**Report to
Development Permit Panel**

To: Development Permit Panel **Date:** November 7, 2002
From: Joe Erceg **File:** DP 92-316
Manager, Development Applications
Re: **Request by Christopher Bozyk Architects Ltd. for a General Compliance
Ruling at 21720 Fraserwood Way**

That the attached landscape plans be considered to be in general compliance with Development Permit 92-316.

EZ-1

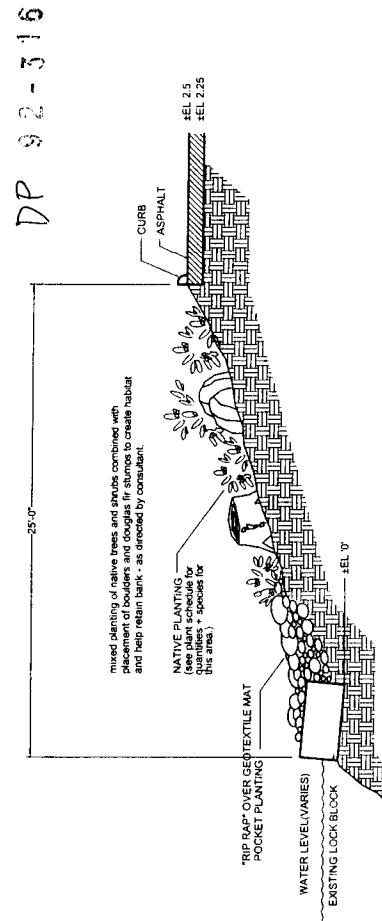
The solution is to re-landscape the sloped area along the ditch with native plants. The strip averages about 14 ft. in width, and incorporates a much larger area on the east of the site. Staff generally find these plans to be a beneficial solution because the restored area is larger than the original preserved area. The original plans called for a 4.25m (13.944 ft.) wide landscaped area next to the ditch.

The consultants are making an effort to restore the lost ESA. Although it will take a few years to grow and fill in, staff find that the 550 plants proposed are all true native Richmond plants and should be successful. Because a number of people in the local area are interested in the outcome, the Development Permit Panel might be a good forum to inform people about the restoration plans and to obtain feedback. Staff will endeavour to notify people about the plans and the meeting date.

N
PP 92316 P.2

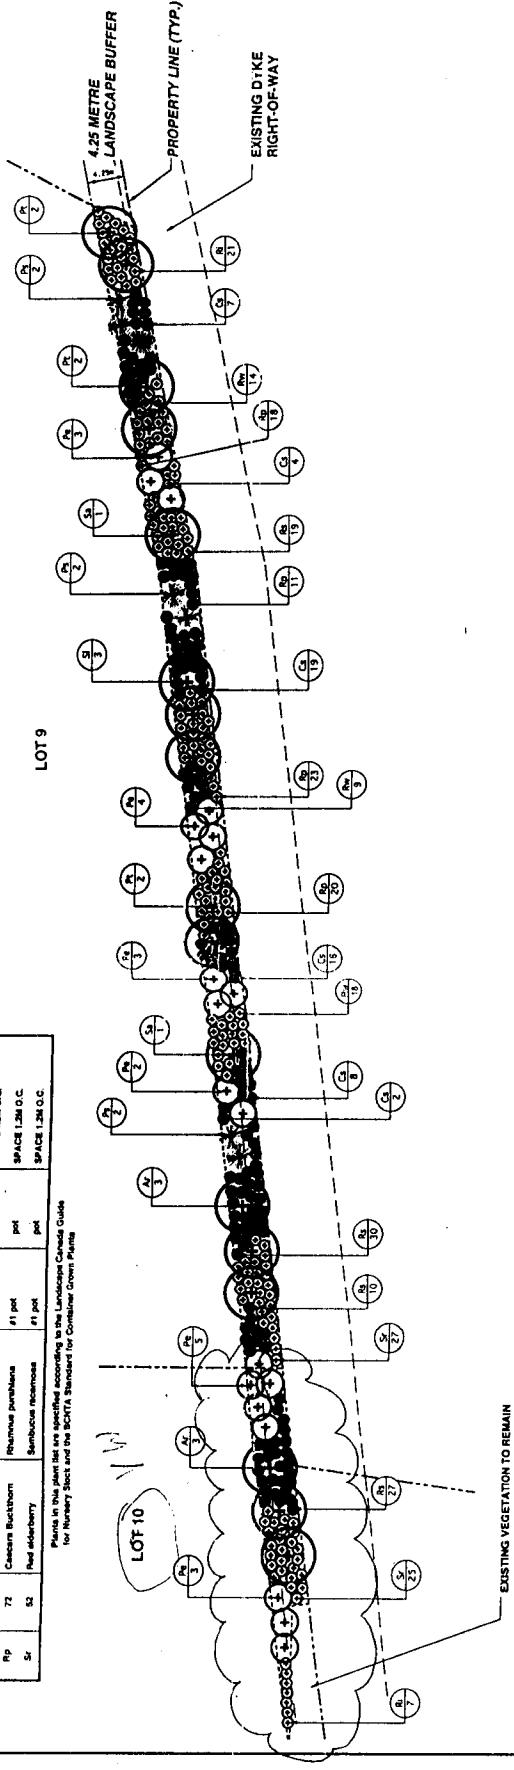
A copy of the proposed landscaping and the original plans are appended to this report. On the original plans, the part which has been altered is shown with a "bubble".
